Addendum #1

Date	Owner Property Number	BHDA Project Number
Tue, 23 Apr 2024	501-3450	2326

Project Designation	Project Address
Tooele UT Deseret Peak Sr Seminary	Approx. 2234 North Berra Boulevard Tooele, Utah

Site Architectural Plan
C111

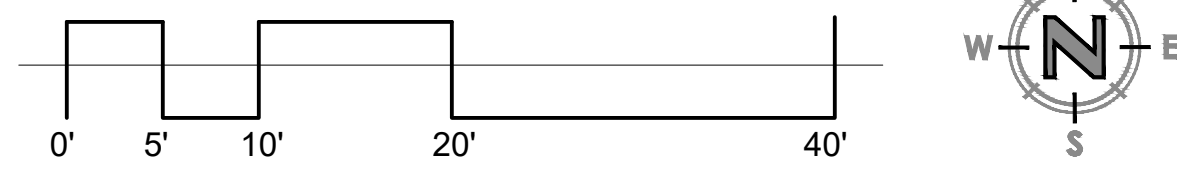
4.01. Sheet C111 Site Architectural Plan

- A. Replace this sheet with the attached revised sheet.
 - 1. Added site fence at west and north property lines.

A702

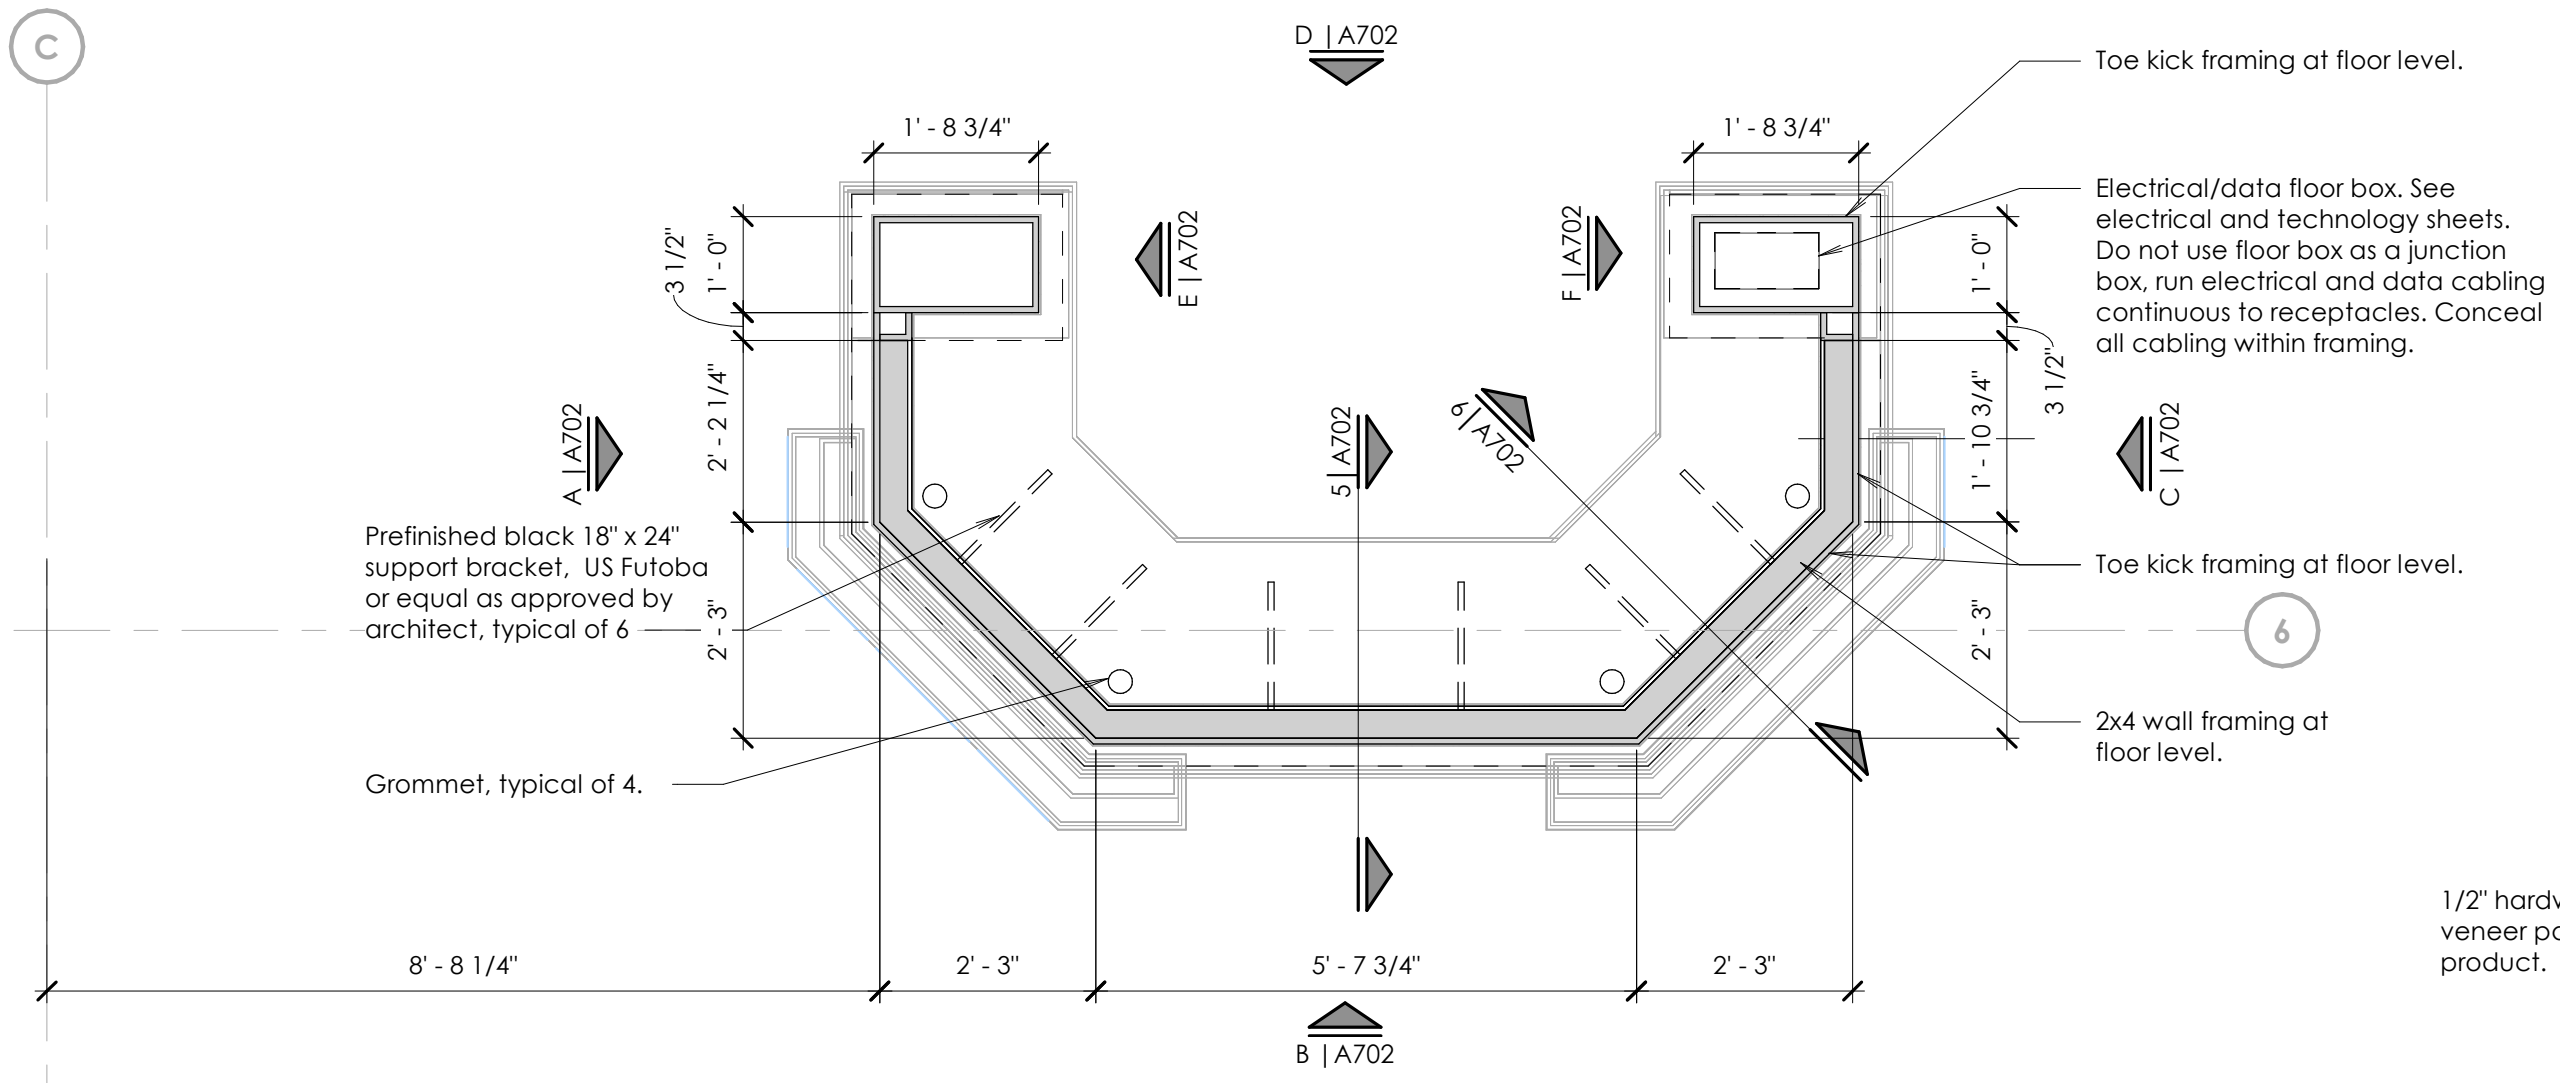
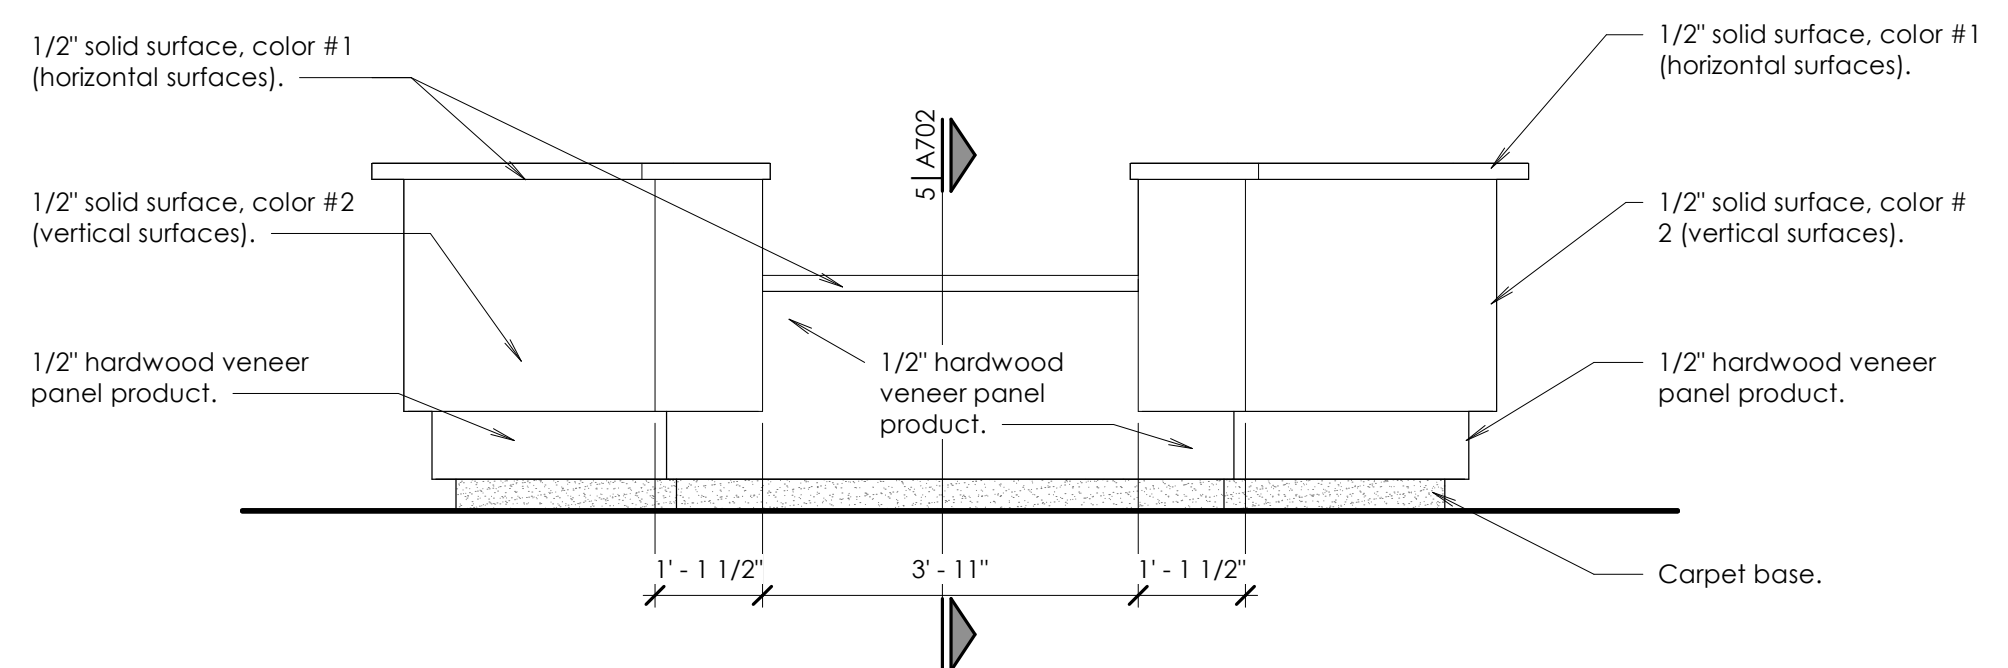
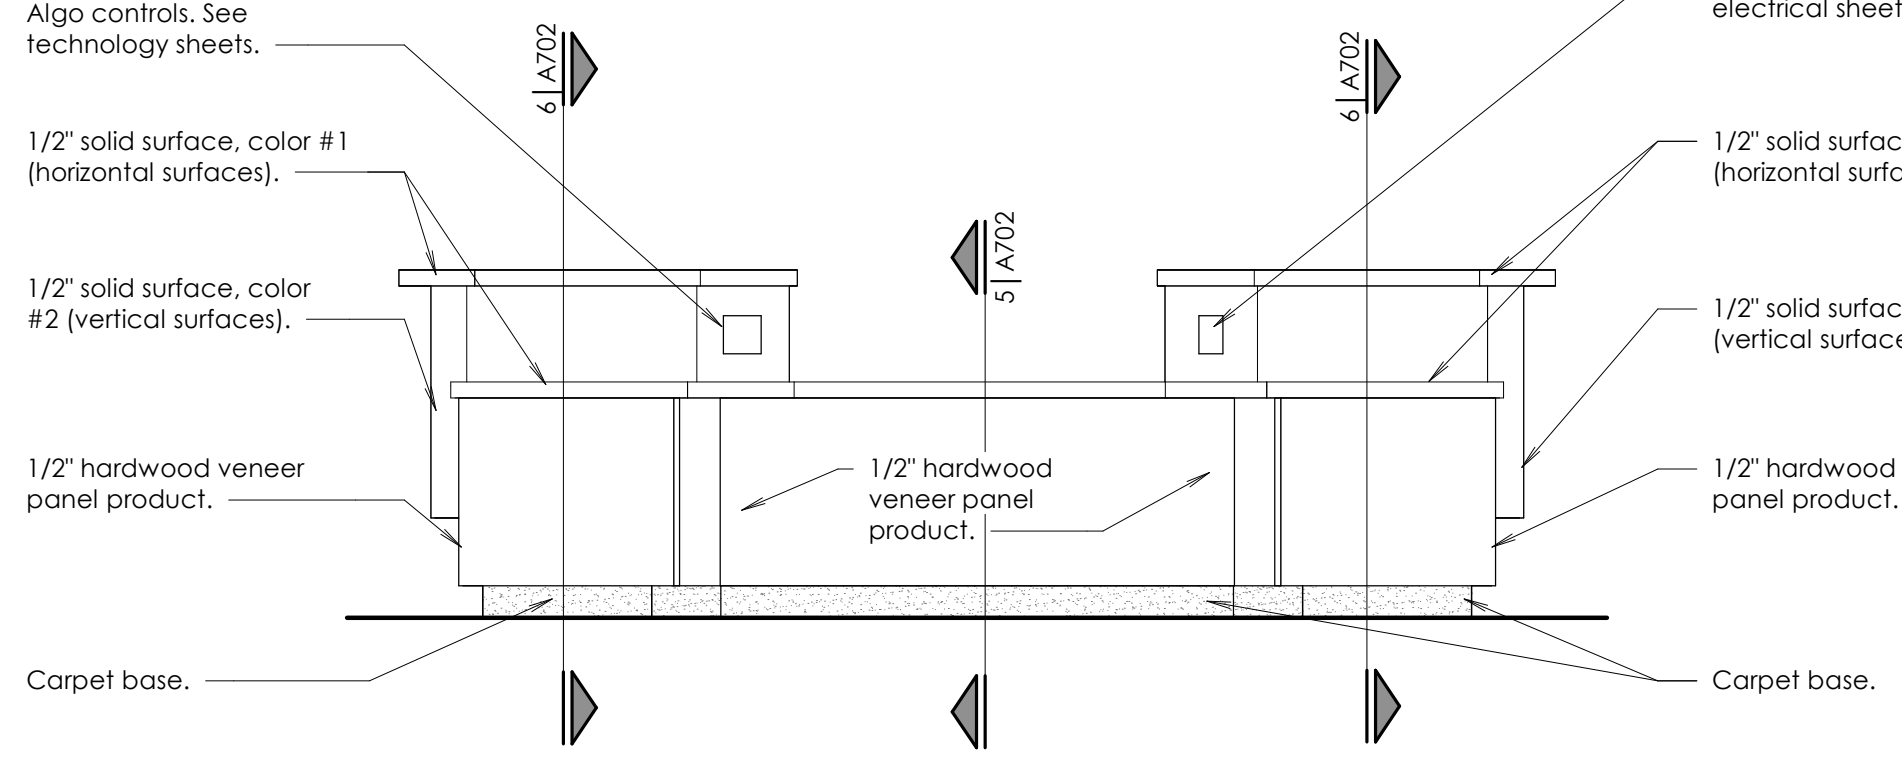
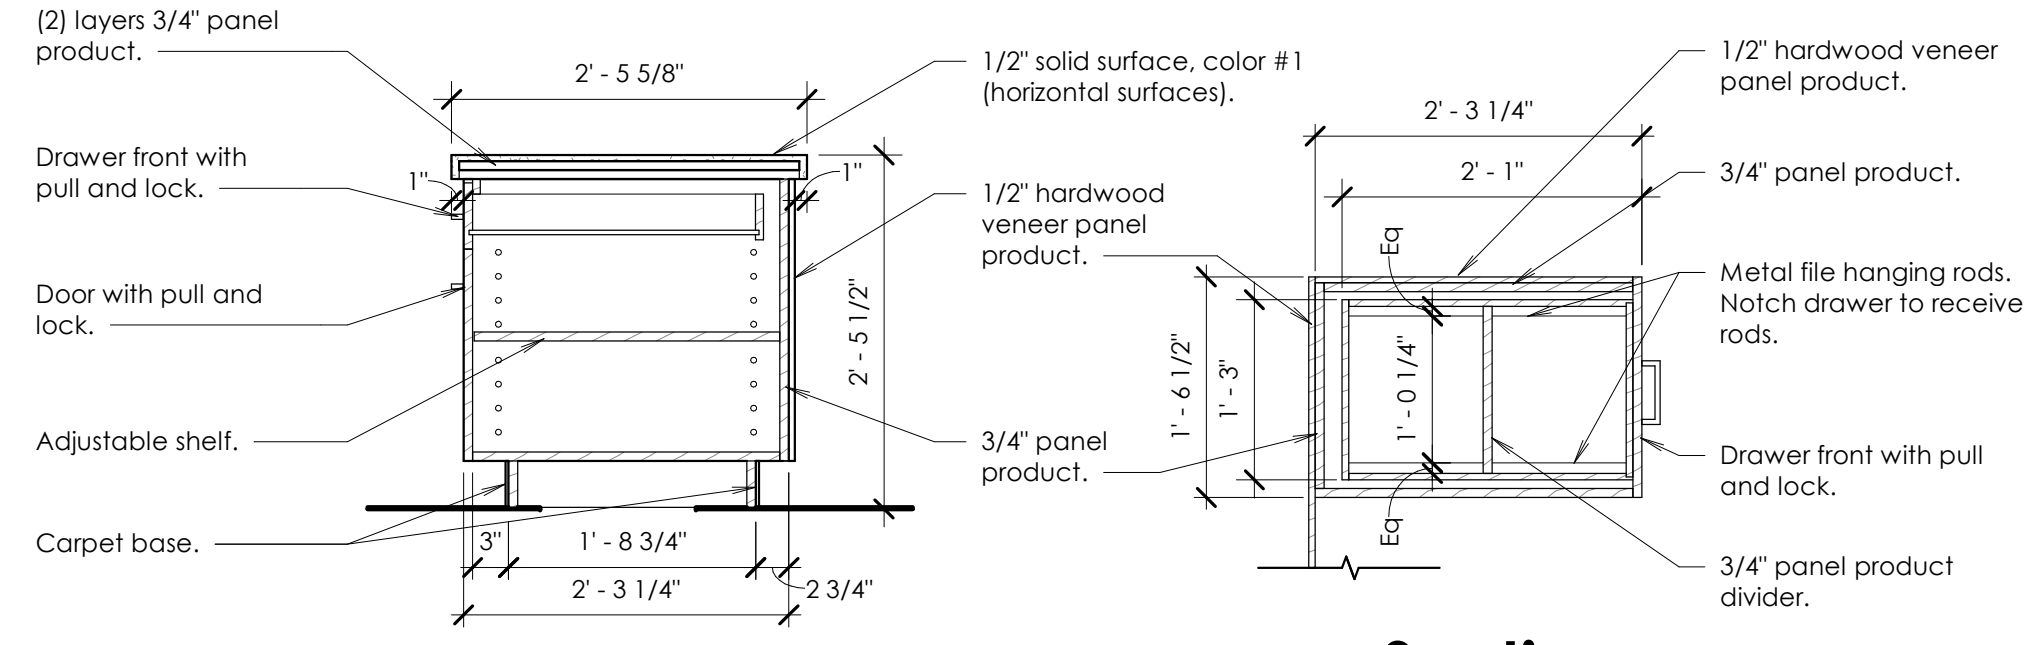
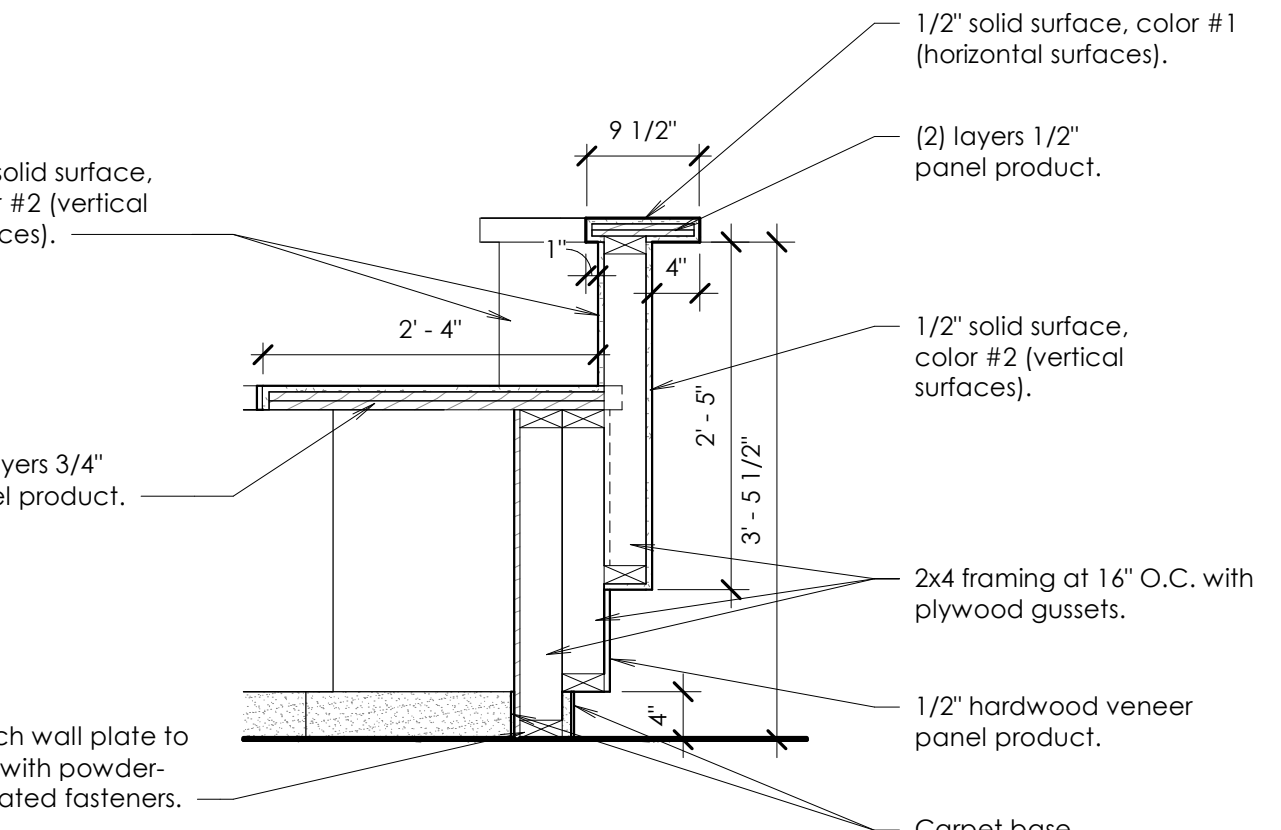
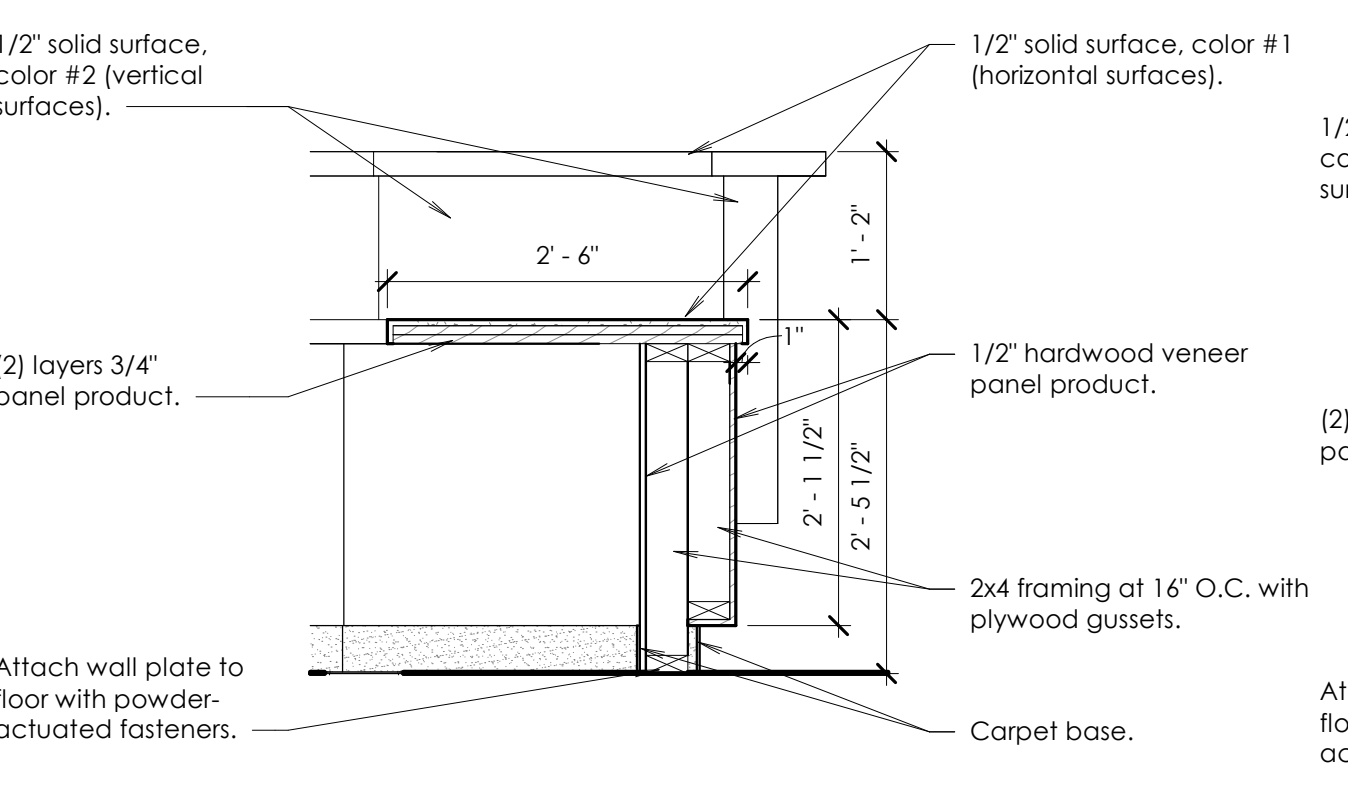
4.05. Sheet A702 Casework Details

- A. Replace this sheet with the attached revised sheet.
 - 1. Modified miscellaneous details and notes.
